Proposed Tourist Park
Kirkwood Road, Tweed Heads South

TRANSPORT IMPACT ASSESSMENT

5 September 2013

This is a revised issue of the report in response to the issues raised by Council in its Request for Further Information dated 23 March 2013 and documented in the JRPP report. The relevant traffic / transport related items and a brief response are provided below.

Figure 6.1 – 12.5m HRV Manoeuvring

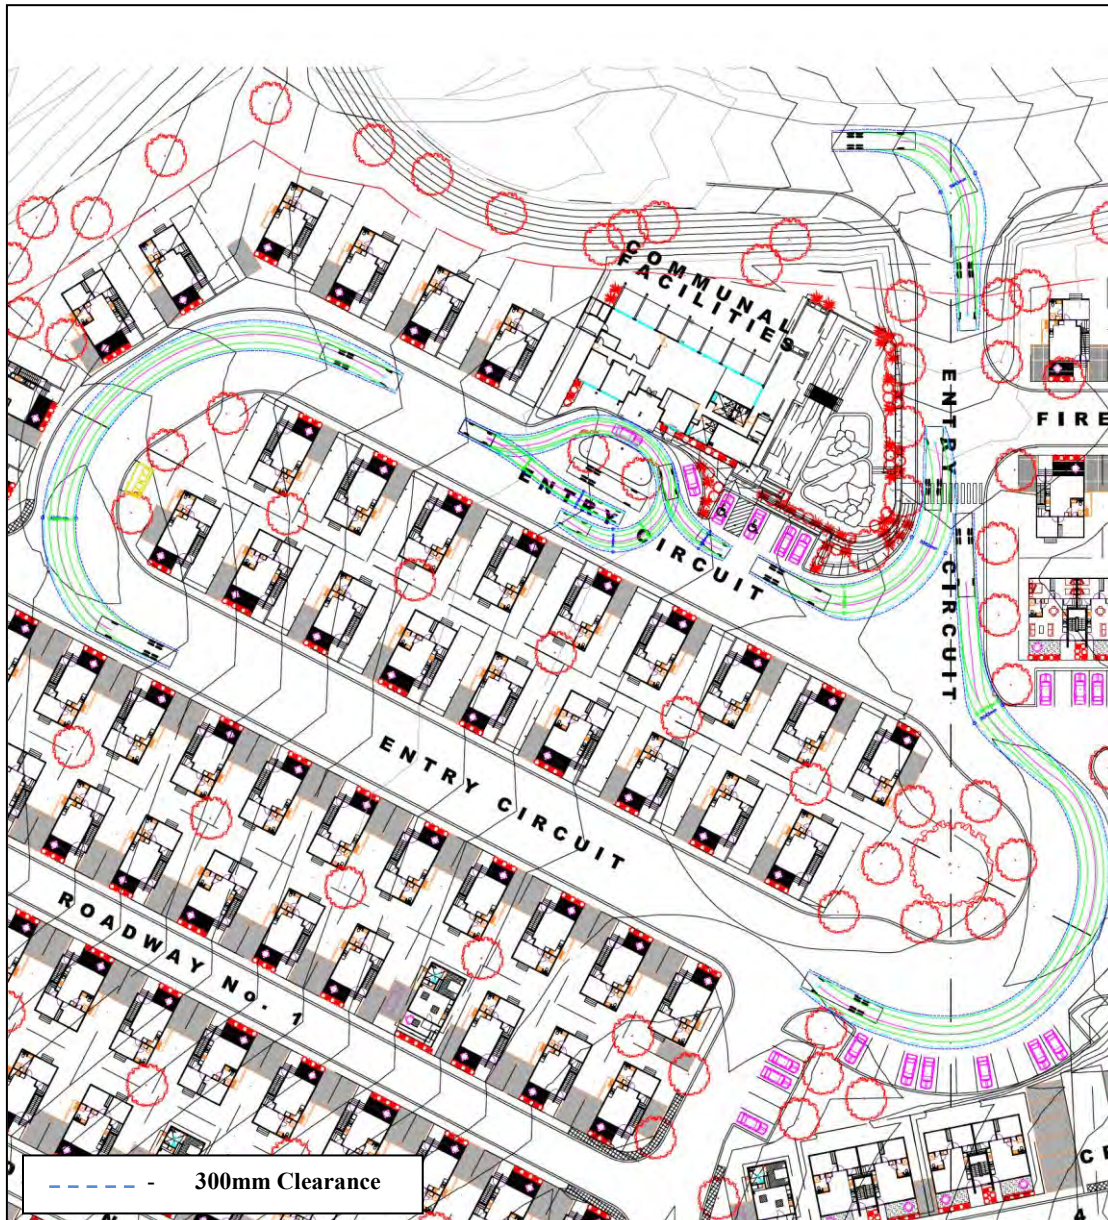
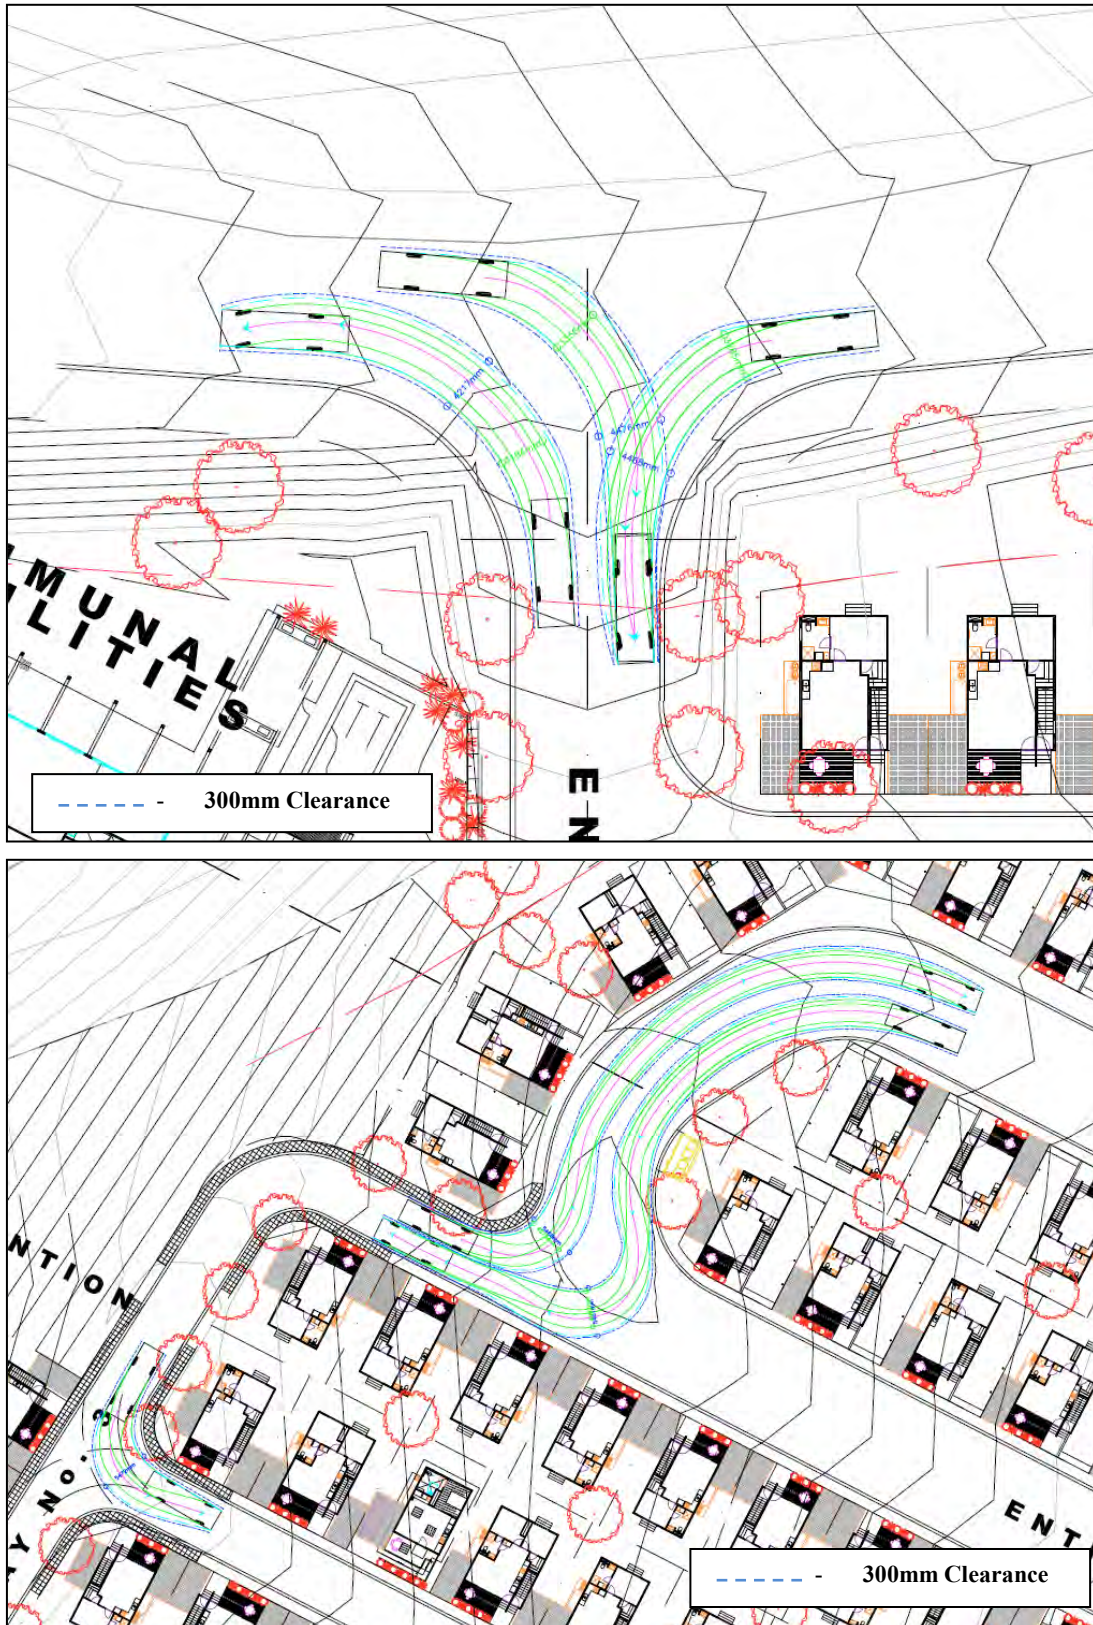
- i. Service vehicle pickup and delivery for the facility is not specified in the Transport Impact Assessment. Please demonstrate that site servicing activities such as on site garbage collection and deliveries are adequately catered for and are free of pedestrian conflict, noting that service vehicles should enter in a forward direction.

Section 2A of the Tweed Shire Development Control Plan specifies that provisions should be made to allow a Heavy Rigid Vehicle (HRV) to enter and exit the site in a forward gear while maintaining adequate clearance at all times. As discussed in Section 6.5, HRV access and servicing provisions have been made and swept path analysis conducted to determine the ability for such a vehicle to manoeuvre throughout the development.

Figure 7.2 – Temporary Kirkwood Road Access Plan

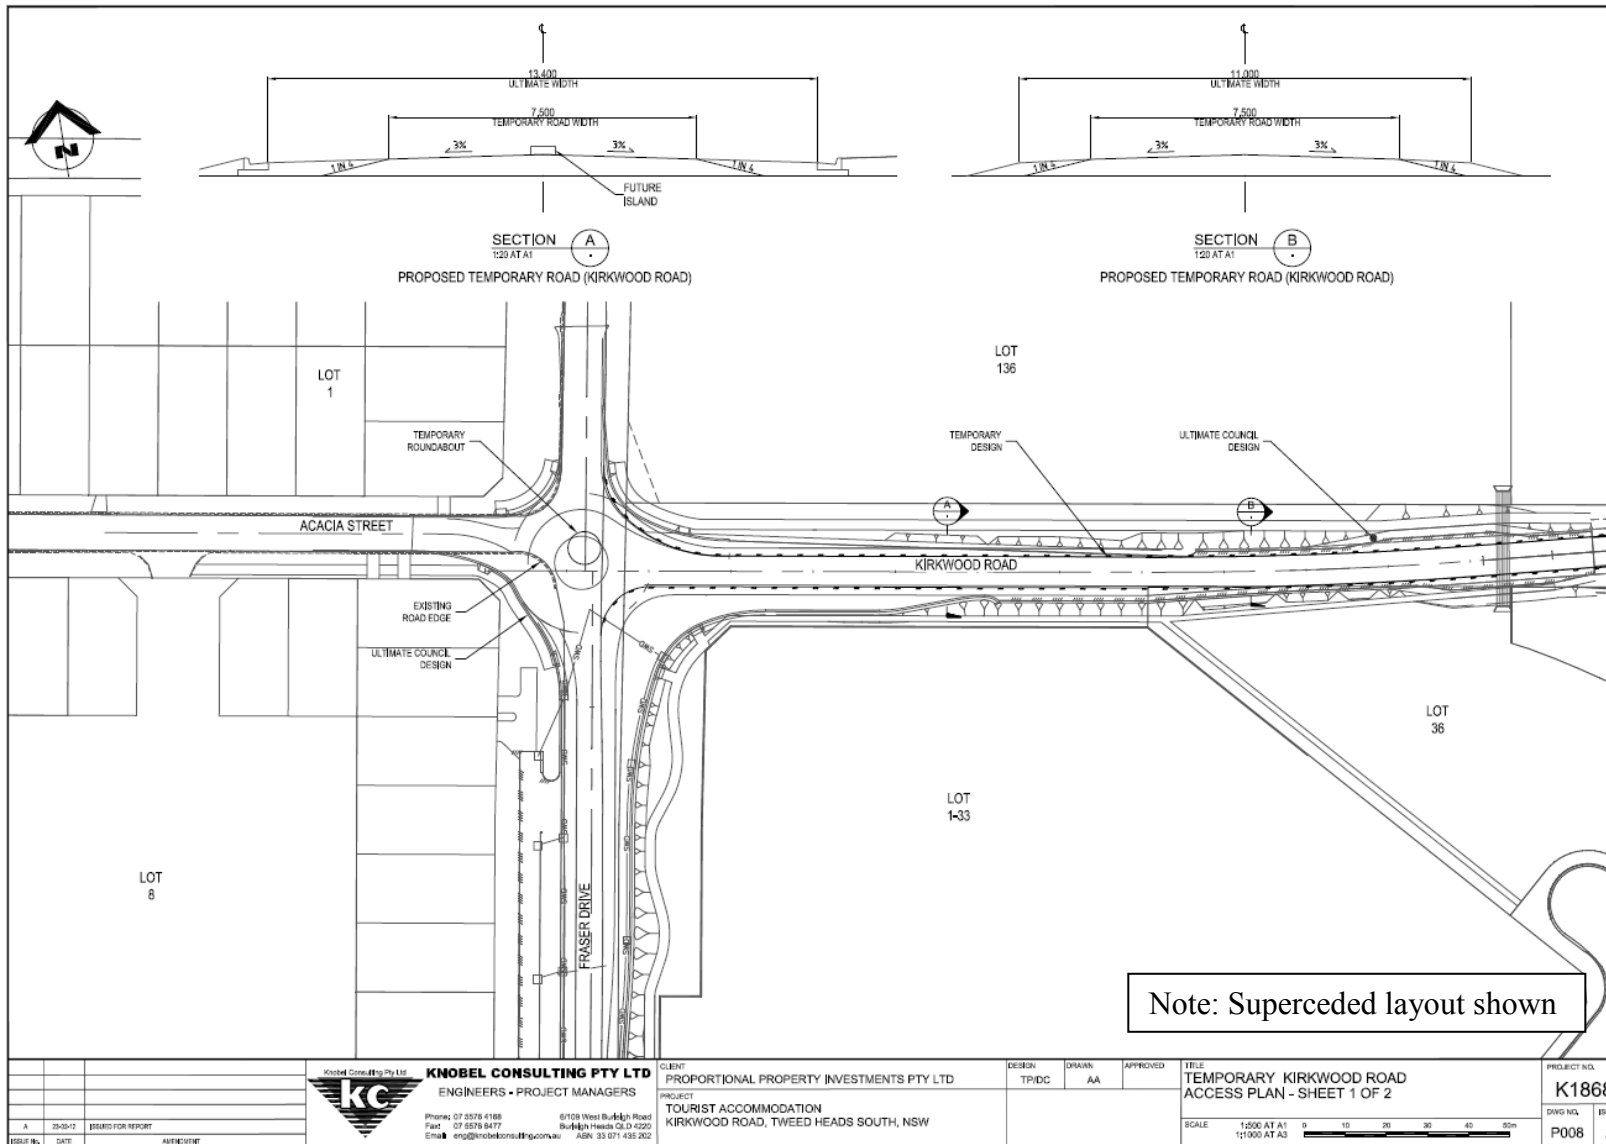
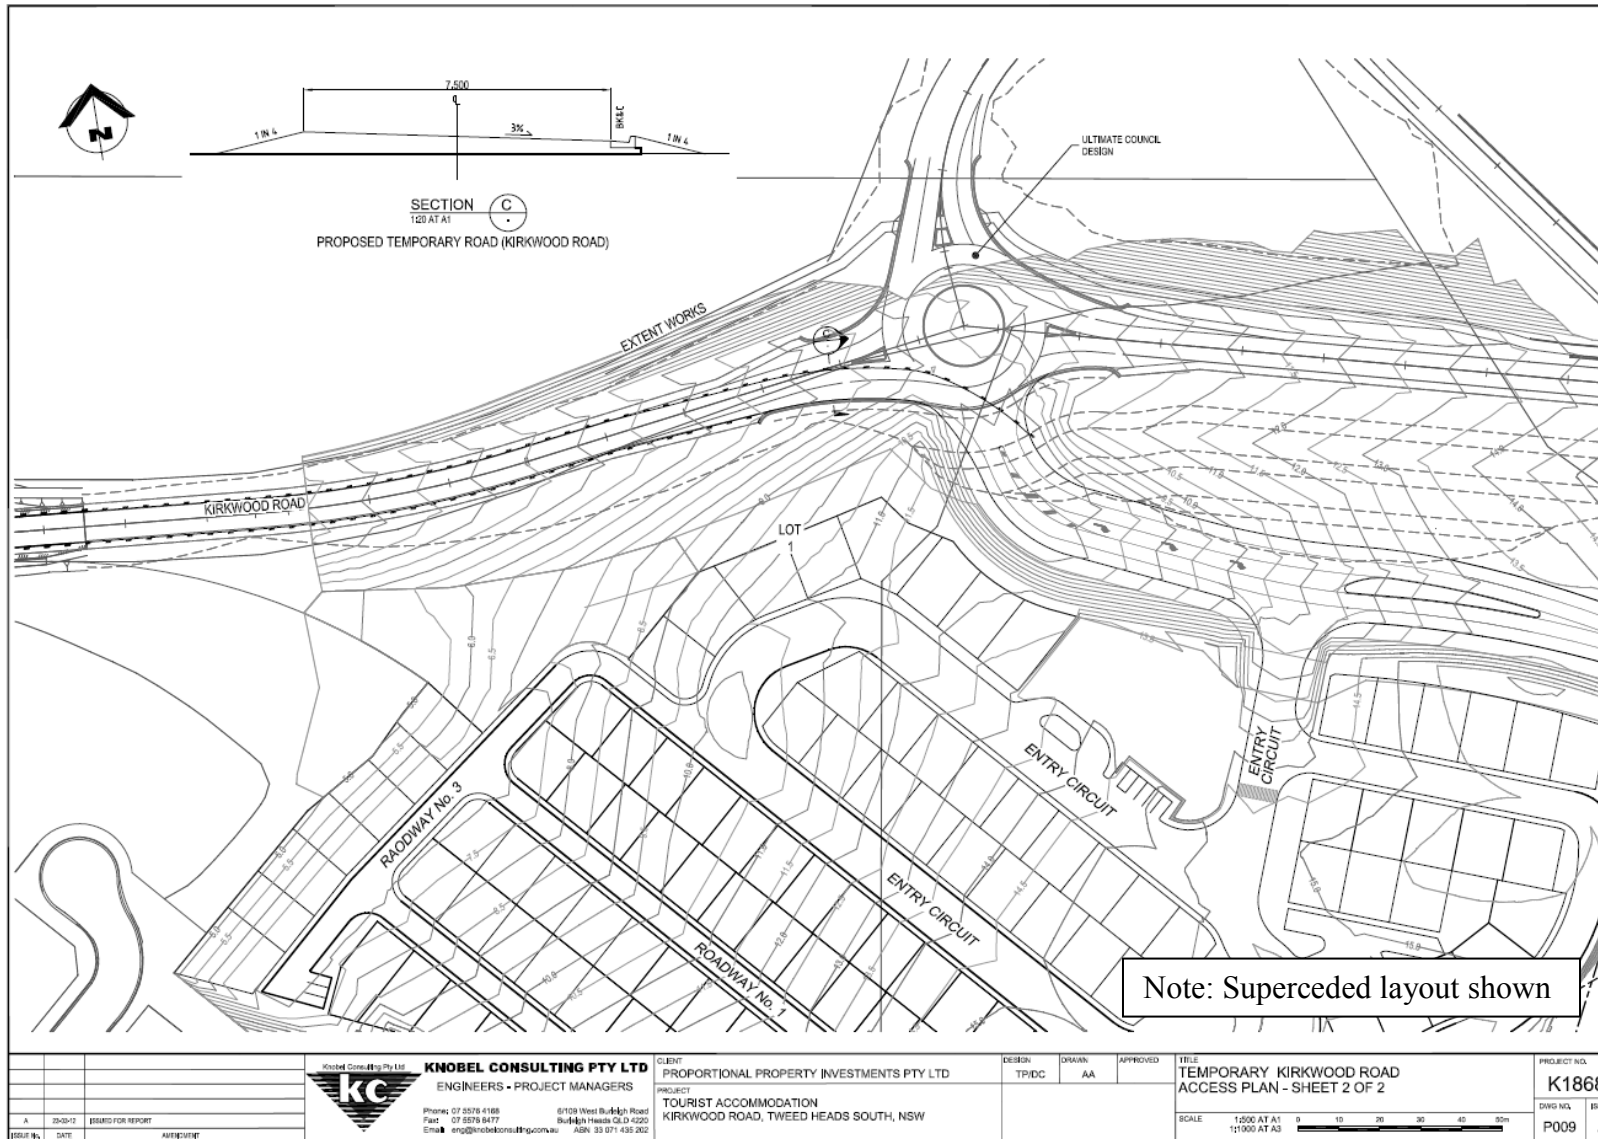
The architectural design drawings show a road connection from the tourist facility to Harrier Street. The impact of the additional traffic on the existing residential area in Harrier Street has not been explored by the Transport Impact Assessment (TIA) supporting the proposal. The TIA is also silent about the impact of traffic generated by the proposal on the intersection of Harrier Street and Fraser Drive. The traffic impacts on Harrier Street and its intersection with Fraser Drive should be quantified,

and any remedial works necessary to limit any adverse impacts identified and implemented prior to connecting the proposal to Harrier Street.

The RMS has advised that it has no objection to the long term access arrangements. However, it has mistakenly interpreted the Harrier Street access as being for general traffic. This access is proposed to be used occasionally for emergency vehicle use. As such a road network assessment is not warranted.
